**Planning Committee****15 September 2014****2014-117-PPF Erect new High School and Halls of Residence****Report Number : PL-08-14-F****Report Presented by Planning Officer –
Development Management, Planning****Development Services
Department Planning Service****Summary**

- 1.1** The proposal is to erect a new High School and Halls of Residence, pupil accommodation, on land to the west of the Clickimin Centre Complex, Lerwick, that amounts to some 9.2 hectares (ha) in area in total. The proposal also involves the overall provision of car parking for 180 cars, separate cycle storage facilities, an access to the site from a new roundabout and entrance on the A970, a turning circle on the access road between the rugby pitch and the running track, a temporary access off North Lochside (which would be reinstated after construction), an upgrade of the paths around Clickimin Loch and the re-profiling and landscaping of the remaining grounds.

Proposed Location Plan with Project Boundary

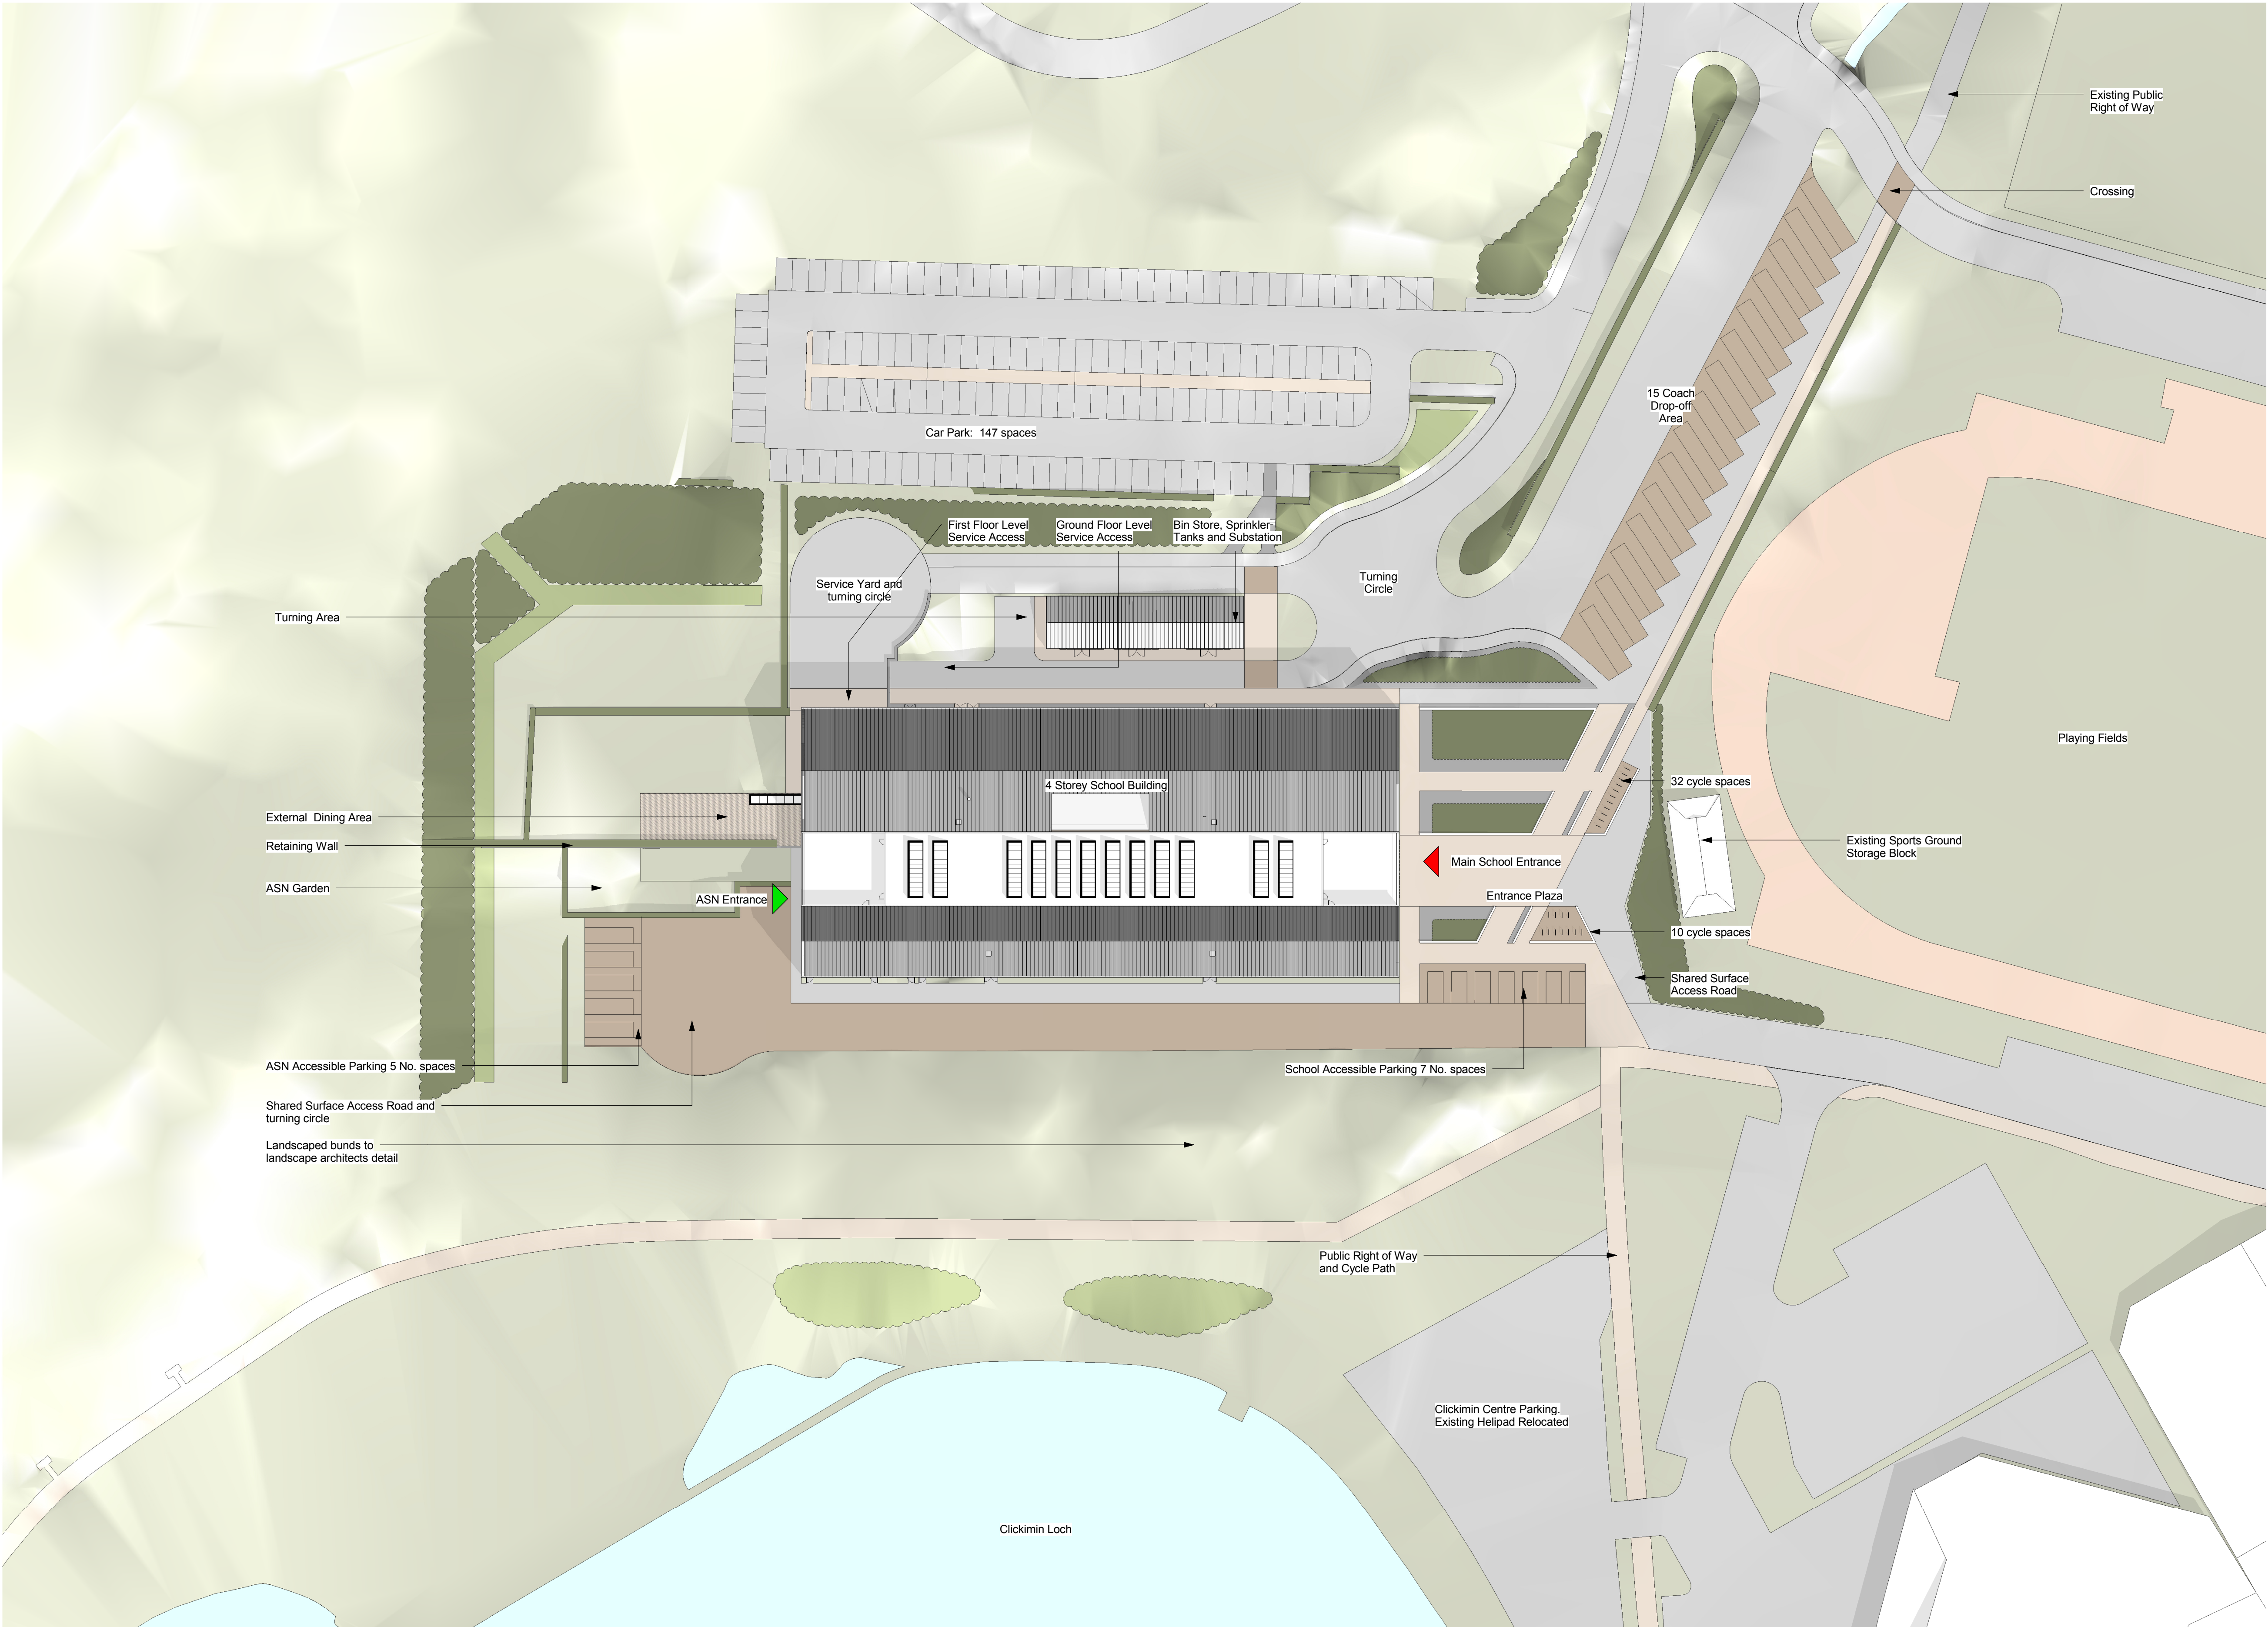
- 4.27 A new car park has been proposed by the applicant adjacent to and to the rear of residential properties at Bruce Crescent that back onto the site, with the intention that it will replace parking provision that will be lost as a result of the construction of the new roundabout on North Lochside that forms part of the proposal. There have been letters of representation received objecting to the construction of this parking

area from the residents whose gardens back onto the car park. In its response to consultation the Roads Service has advised that placing the parking elsewhere would cause other safety issues, and as such this is the preferred location for alternative provision. The Planning Service considers that there is no need to replace the parking provision that will be lost on North Lochside, especially if the alternative provision will be to the detriment of the amenity, especially in terms of noise, which is currently enjoyed by the residents at Bruce Crescent or would otherwise cause safety issues if constructed elsewhere. Additionally it is not considered that the proposed car parking is required for site specific provision. As a result it is recommended that this aspect of the development should not be approved and an appropriate condition has been recommended.

(3) Notwithstanding the approved plans and Condition1 above the car parking provision shown on Drawing No 110-03-Rev03 and annotated "Car Parking to Replace Spaces Lost by Formation of Roundabout" is not approved.
